Access Compliance Report Public Rights-of-Way (Curb Ramps)

Main Street: JACKSON_ST Cross Street: MCFADDEN_AVE Location: NE

ADA ID: RPRK211005151149 Ramp Type: Type 1 - Perpendicular Diagonal Initial Pass/Fail: Fail Overall Compliance: No Severity Score: 15

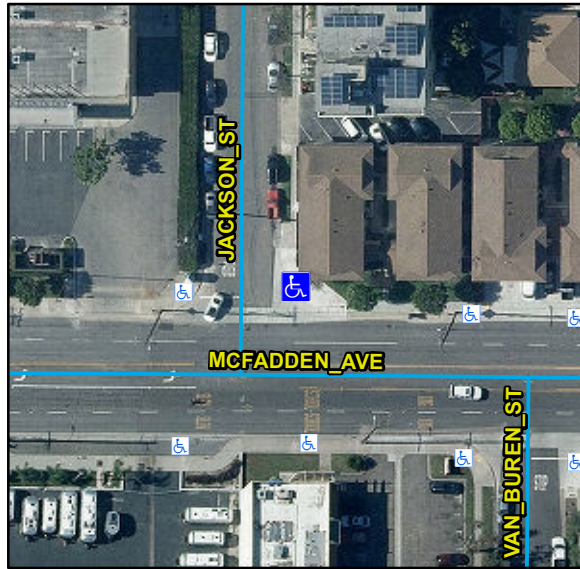
Compliance	Description	Data	Compliance	Description	Data
N/A	Ramp Length (in)	109	N/A	Flare Type LT	
Yes	Ramp Width (in)	48			N/A
No	Ramp Run Slope (%)	11.4	N/A	Flare Slope LT (%)	N/A
Yes	Ramp Cross Slope (%)	1.8	N/A	Flare Traversable LT	N/A
N/A	Landing Present	N/A	N/A	Flare Type RT	
N/A	Landing Length (in)	N/A			N/A
N/A	Landing Width (in)	N/A	N/A	Flare Slope RT (%)	N/A
N/A	Landing Run Slope (%)	N/A	N/A	Flare Traversable RT	N/A
N/A	Landing Cross Slope (%)	N/A	N/A	DWS Provided	N/A
N/A	Landing Movement Obstructed?	N/A	N/A	DWS Contrast	N/A
	Landing Movement Type	N/A	N/A	DWS Length (in)	N/A
N/A	Landing Shared	N/A	N/A	DWS Full Width	N/A
N/A	Clear Space	Yes	N/A	DWS Offset Left (in)	N/A
N/A	Clear Space To Crosswalk (in)	N/A	N/A	DWS Offset Right (in)	N/A
N/A	Marked Crosswalk 1	No	N/A	Marked Crosswalk 2	No
	Crossing 1 Direction	W		Crossing 2 Direction	S
	Marked Crosswalk 1 Width (in)	N/A		Marked Crosswalk 2 Width (in)	N/A

Remove & Replace Curb Ramp With Two New Directional Ramps or Equivalent.
